**STATE OF NEVADA COMMENTS
ON THE U.S. DEPARTMENT OF ENERGY'S
DRAFT ENVIRONMENTAL IMPACT STATEMENT
FOR A
GEOLOGIC REPOSITORY FOR THE DISPOSAL OF
SPENT NUCLEAR FUEL AND HIGH-LEVEL RADIOACTIVE WASTE
AT YUCCA MOUNTAIN, NYE COUNTY, NEVADA**

**Prepared by
The Nevada Agency for Nuclear Projects
Office of the Governor**

**Carson City, Nevada
February 28, 2000**

Figure 1: Schematic design of the drip shield and waste package (CRWMS, 2000a).

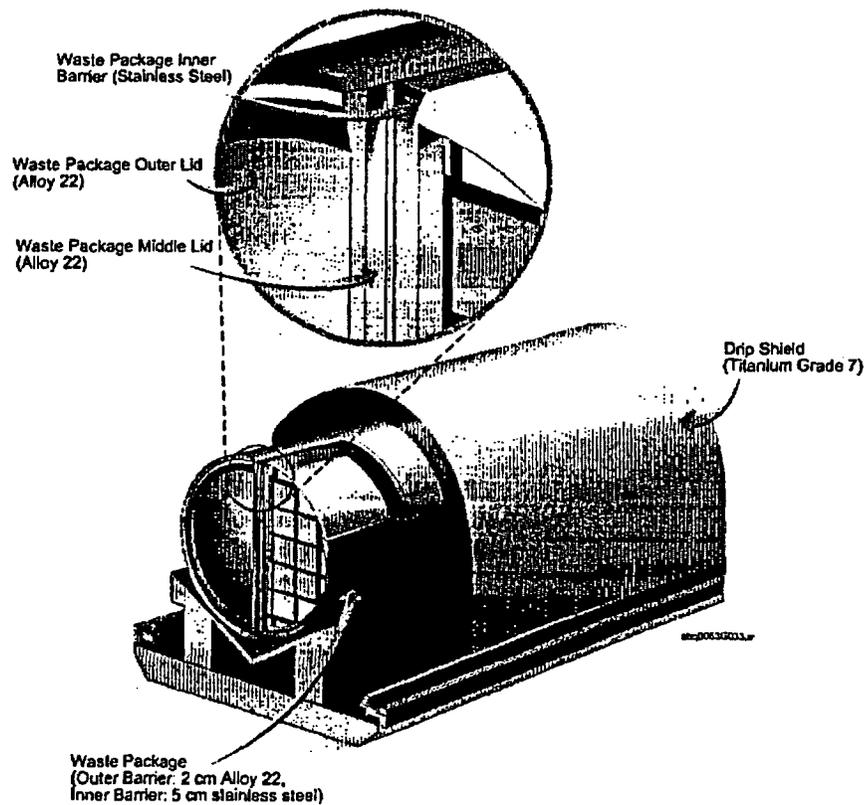
In the current design, the drip shield is largely redundant since the Alloy-22 barrier is somewhat more effective. However, the use of dual barriers of dissimilar materials provides defence-in-depth and contributes to the overall confidence in the system.

Figure 2: General engineered barrier design features, initial water movement, and rockfall (CRWMS, 2000a).

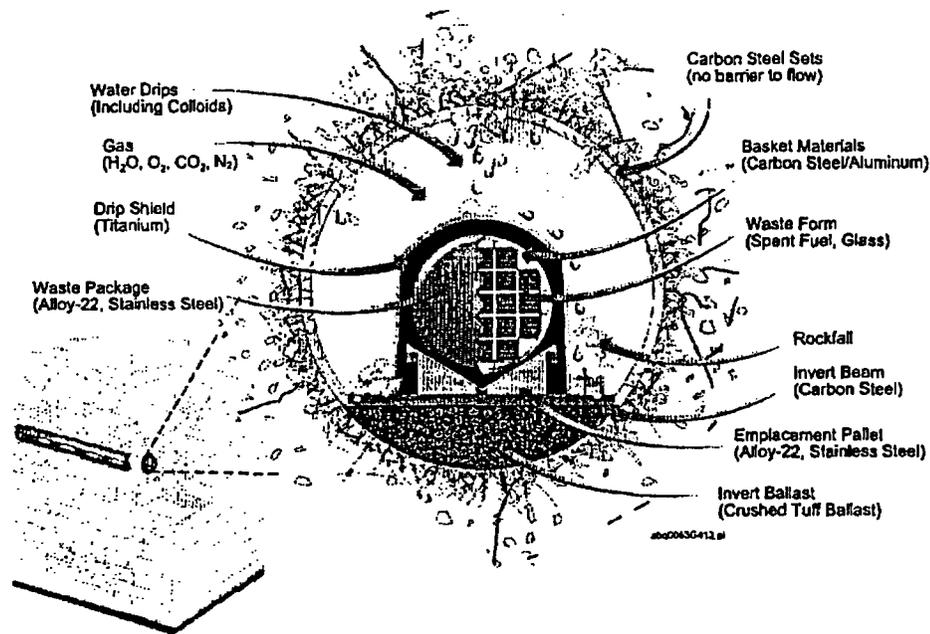
The second mechanism, which is dominant for many millennia after the waste package is breached, is overly conservative and complex and possibly not credible. The model requires a continuous film of water to allow diffusion that extends all the way from the waste form to the cracks in the degrading waste package and to the bottom of the invert. In applying the model, the TSPA-SR assumes very conservatively that the process of diffusion occurs even when there is no dripping in the location and the drip shield is intact. Furthermore, as discussed below, the existence of a continuous water film seems most unlikely because of evaporation. Moreover, the presence of the emplacement pallet (see Figure 2) is ignored and the waste package is assumed to be lying on the invert.

Figure 3: Conceptual drawing of mountain-scale flow processes (CRWMS, 2000a).

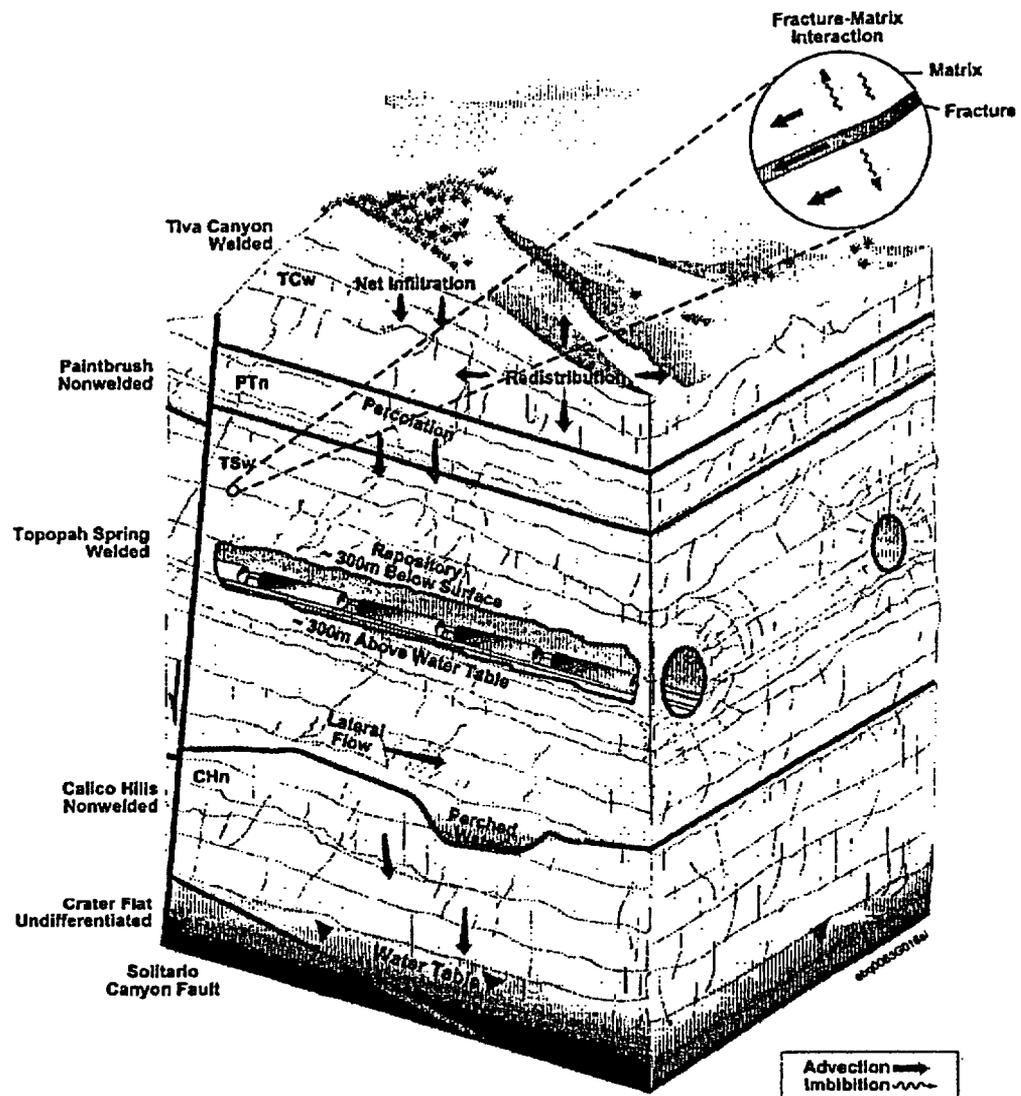
The description of transport in the UZ is clearly written and the illustrative figures (see Figures 3.7-9, 10 and 12 in the TSPA-SR) are useful. They show that the average transit times in the UZ are typically 500 to 1 000 years for non-sorbing species such as ^{99}Tc , 1 000 to 10 000 years for ^{237}Np and >100 000 years for irreversibly and reversibly-bound Pu, respectively. This illustrates the ability of the Yucca Mountain geological strata to retain radionuclides, a fact that is otherwise masked in the TSPA-SR by the dominance of engineered barriers for the first 10 000 years and more.

Figure 4: Conceptualisation of features and processes important to saturated zone transport (CRWMS, 2000a).

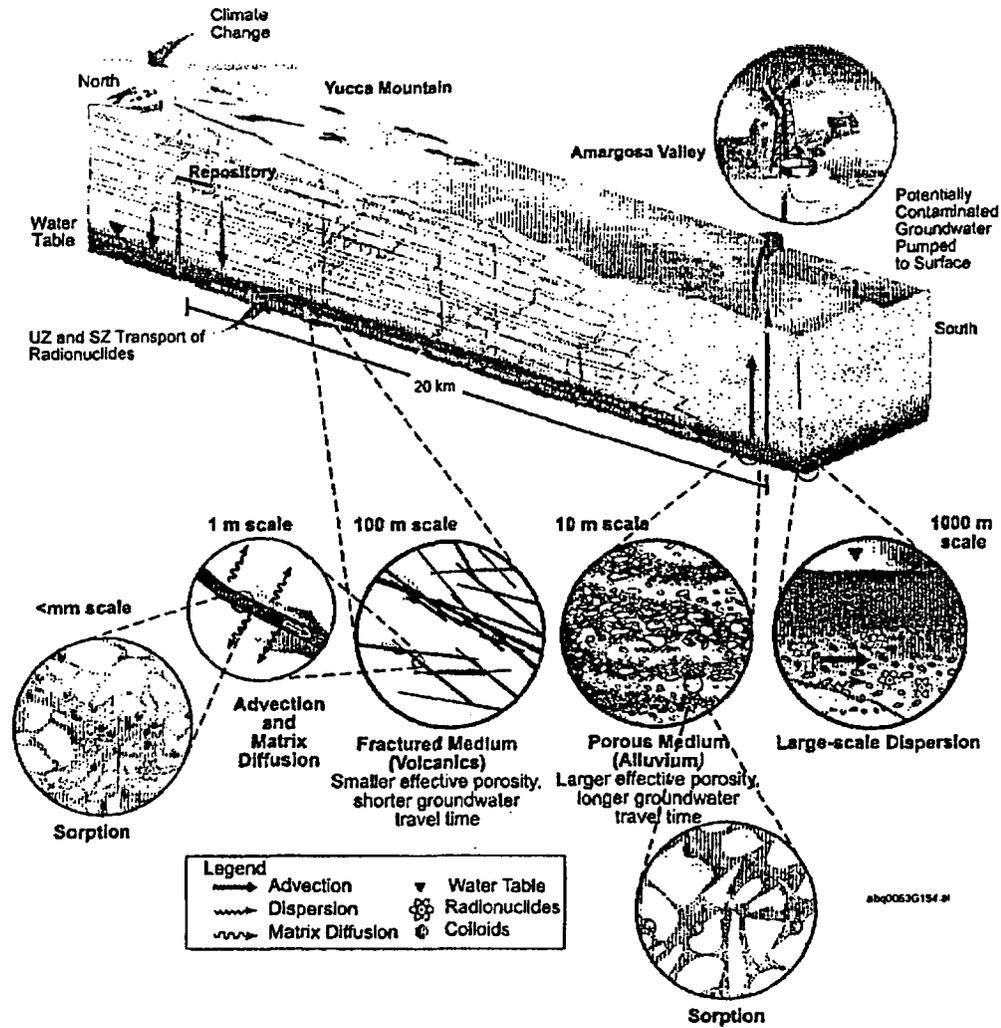
The IRT observes that the SZ flow system at YM is very complex and not sufficiently understood to propose a conceptual model for a realistic transport scenario. A number of site specific features have to be investigated in the continued site investigations before a realistic flow model can be built. This is discussed in detail in Appendix 3 and summarised below.

Figure 5: Groundwater basins in the Yucca Mountain vicinity (DOE, 1999).

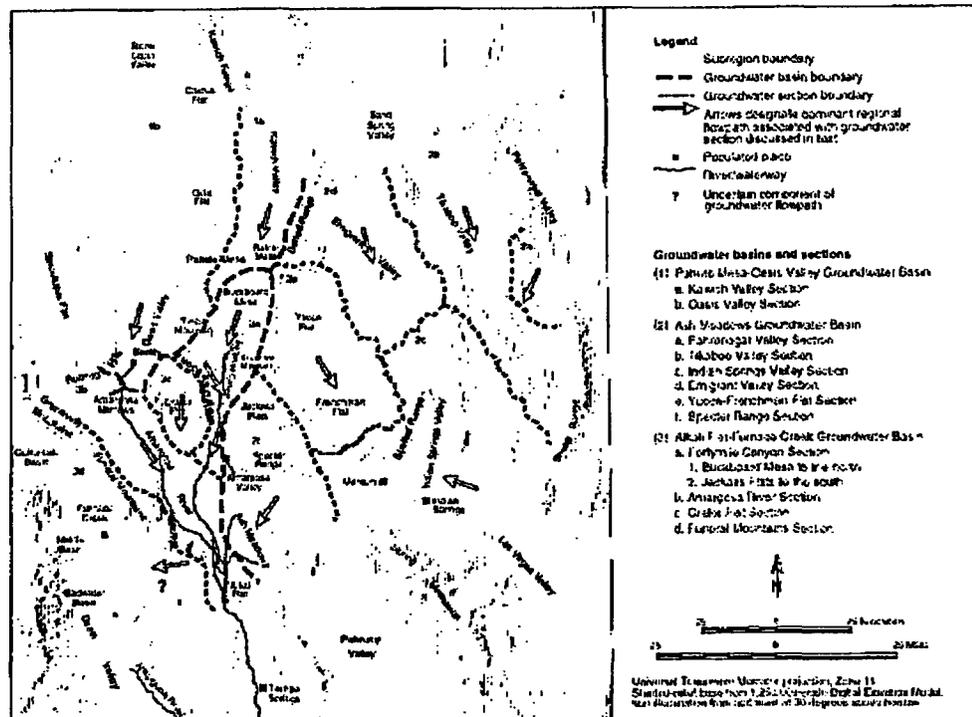
The IRT considers that this may be a relevant issue in the case of Yucca Mountain, because, contrary to most international planned repositories whose final outlet is the sea, Yucca Mountain is a closed basin system. Thus all releases will eventually end up in some location within the basin (see Figure 5). There is therefore a risk that accumulation and possible reconcentration of radionuclides could occur, leading to potential non-trivial doses.

- For a wetter climate, the TSPA-SR indicates that Death Valley would become a lake again (Lake Manley), and that Fortymile Wash and the Amargosa Valley (see Figure 5) would become perennial streams and eventually discharge into this lake. Will the radionuclides leaving the repository end-up also in this lake? Over what time scales? What would be the fate of the radionuclides in this water, can they reconcentrate, and is there a potential pathway to man?
